**CERTIFICATE OF APPROPRIATENESS**

**Property:** 1409 Ashland Street, Lot 16, Tract 17A, Block 151, Houston Heights Subdivision. The property includes a historic 1,114 square foot, one-story wood frame single-family residence and a detached secondary structure situated on a 6,600 square foot (50' x 132') interior lot.

**Proposal:** Alteration – Construct a 2,595 square foot two story addition behind and on top of the existing residence.

**NORTH SIDE ELEVATION**

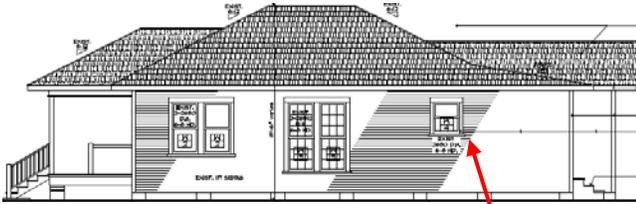
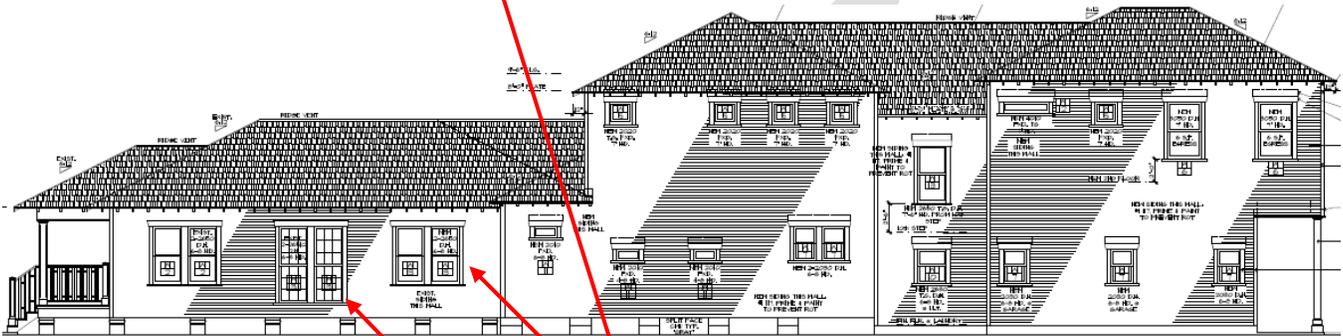
*SINGLE WOOD WINDOW WILL BE REMOVED AND REPLACED WITH PAIR OF WOOD WINDOWS*

*ALUMNIUM WINDOWS TO BE REPLACED WITH WOOD WINDOWS; WINDOW OPENINGS WILL BE REDUCED TO MATCH EXISTING WOOD WINDOWS; SIDING WILL BE PATCHED*

**SOUTH SIDE ELEVATION**

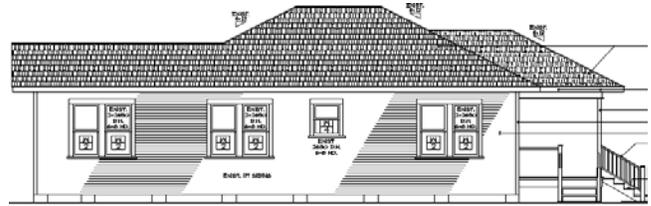
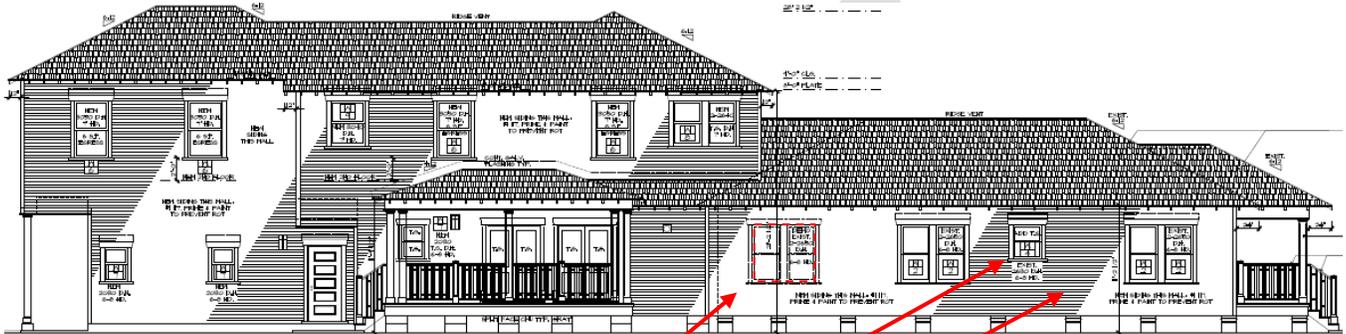
*WOOD WINDOWS TO BE REMOVED AND PATCHED WITH SIDING*

*ALUMINIUM WINDOW TO BE REPLACED WITH WOOD WINDOW*

*ALL EXISTING WOOD SIDING ON THIS WALL WILL BE REMOVED AND REPLACED*

**ORIGINAL REAR WALL LOCATION ON NORTH WALL**

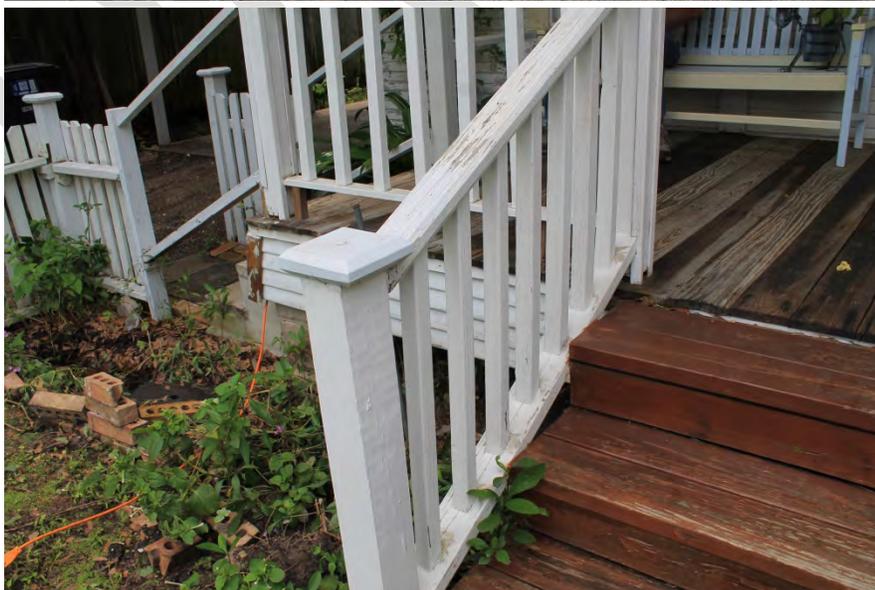
*REAR SHED ROOF  
ATTACHED TO MAIN HIP*

*SEAM IN SIDING SUGGESTS END POINT  
OF ORIGINAL SIDING*
